SERVICE BULLETIN

APPLICABILITY: 2013MY BRZ

NUMBER: 12-152-13

SUBJECT: Door Mirror Loose / Vibrating

Arrow indicates where to look for the three Phillips screws.

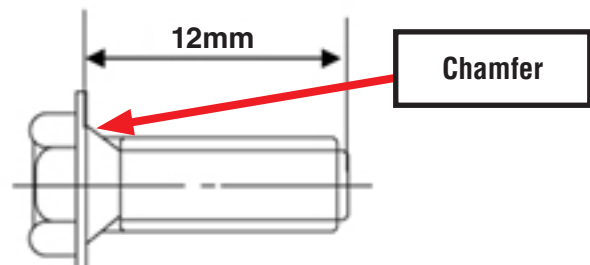
1. Follow the procedure outlined in the applicable Service Manual for removing the mirror assembly. After removing the mirror assembly, remove the 3 Phillips screws which hold the mirror head to the base as circled in the photo below.

NOTE: This service procedure applies only to mirror heads secured to their mounting base with Phillips screws. If you find the new hex-head bolts are already in place, diagnose the cause of the loose mirror head and repair or replace accordingly.

IMPORTANT: Avoid damaging the Phillips drive portion of the screws by using a good No. 2 size Phillips screw driver. They are installed with a thread locking compound and may require some extra force to remove.

2. Apply thread locking compound to the bolt threads as shown above. Follow the instructions on the product packaging for proper curing time. Install and torque the 3 mounting bolts to 4 Nm, (35.4 inch-pounds).
3. Reinstall the mirror assembly in the reverse order of removal.
